### **MEMORANDUM**

Preliminary Plan of Subdivision

**PROJECT NAME:** Hillmead/Bradley Hills

120060480

Preliminary Plan Attachment "A"

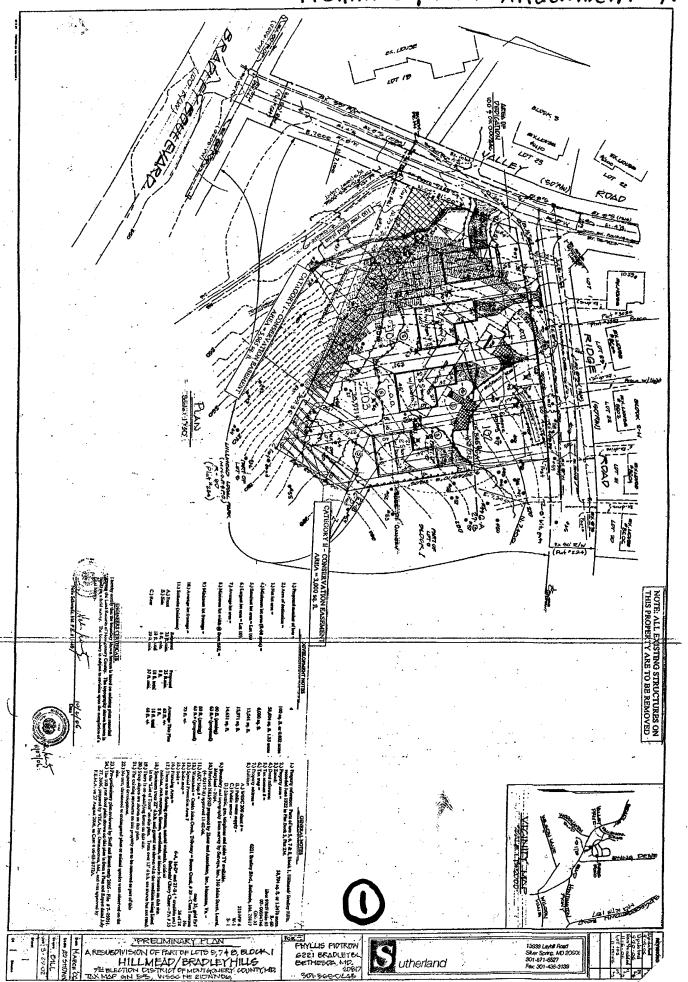
This application is a request for resubdivision of the Subject Property into 4 residential lots (Attachment A). The preliminary plan shows three lots with access to Ridge Road. Two of these lots will use portions of the existing loop driveway, while a third has its own driveway. The fourth lot will access Valley Drive with a single driveway. Public water and sewer is available to the site. The existing house will be removed. The limits of disturbance shown on the plan maximize tree protection on the Property

<u>Suitability for Residential Use:</u> Although a portion of proposed Lot 105 is encumbered by floodplain and steep slopes, neither render the lot unsuitable for residential development. The analysis of lot suitability in the previous staff report did not include consideration of floodplain and steep slopes. A floodplain was not identified by the Montgomery County Department of Permitting Services (DPS) during their initial review of the preliminary plan application. The FEMA floodplain, and its associated 25-foot building restriction area, will not be disturbed by development on proposed Lot 105. For a detailed discussion of floodplains refer to Section 4A (a), below.

Steep slopes, while shown on the original preliminary plan drawing, were not specifically addressed. The steep slopes on the Subject Property are not associated with a perennial or intermittent stream and; therefore, may be constructed upon using

The previous staff report suggested that slopes on the site approach 24%. When slopes are measured across the width of Lot 105, where the proposed house would be located, this is a correct statement. However, as reflected on the original and revised plans, the proposed lot also contains areas of 25% or greater slopes, and some 15% slopes on erodible soils that will continue to be impacted by a house on that lot. The initial review did not include an analysis of the impact to the steep slopes under Section 50-32(c), *Environmentally Sensitive Areas*. The Environmental Guidelines distinguish between hydraulically adjacent and hydraulically remote steep slopes, and specifies that development should be avoided on hydraulically adjacent slopes. For the reasons discussed above, Staff has determined that the adjacent channel is ephemeral. Therefore, the steep slopes on the site and adjoining parkland are not adjacent to a perennial or intermittent stream and are considered hydraulically remote. Further, staff has in practice consistently classified steep slopes as being hydraulically remote when they are not integral to or abutting a stream buffer.

For reasons set forth below, staff concludes the mitigation measures proposed will provide reasonably appropriate short and long term natural resource protection. The proposed development will disturb approximately 5,200 s.f. of the steep slopes on the Property. The applicant will minimize the impacts on these slopes by applying the following measures:

- a. Minimizing the area of slope disturbed through placement of houses;
- b. Minimizing grading of steep slopes by using retaining walls instead of flattening the slope:
- c. Using specially designed stormwater management devices (Rainhandlers) to disperse runoff from rooftop on Lots 104 and 105;
- d. Minimizing imperviousness by using porous paving in the proposed driveways;
- e. Submitting an engineered sediment control plan (at time of building permit) to ensure stability during construction;
- f. Permanently stabilizing 0.02 acres of steep slope by planting forest;
- g. Permanently protecting 0.11 acres of steep slope in conservation easements.

Staff's recommended conditions require the above protective measures. Staff has determined that application of these measures will provide appropriate short and long-term natural resource protection pursuant to the Section 50-32(d)(2) requirements. With regard to stormwater and sediment control requirements, DPS is the lead agency. DPS has approved a SWM concept for the proposed subdivision that specifically took into account the steep slopes on this Property by requiring the use of Rainhandlers and minimizing imperviousness. The stormwater management concept includes no waivers for this preliminary plan. DPS must also approve an engineered sediment control plan that will be applied to the site during construction. Although some steep slopes will be destabilized during construction, it is staff's judgment that
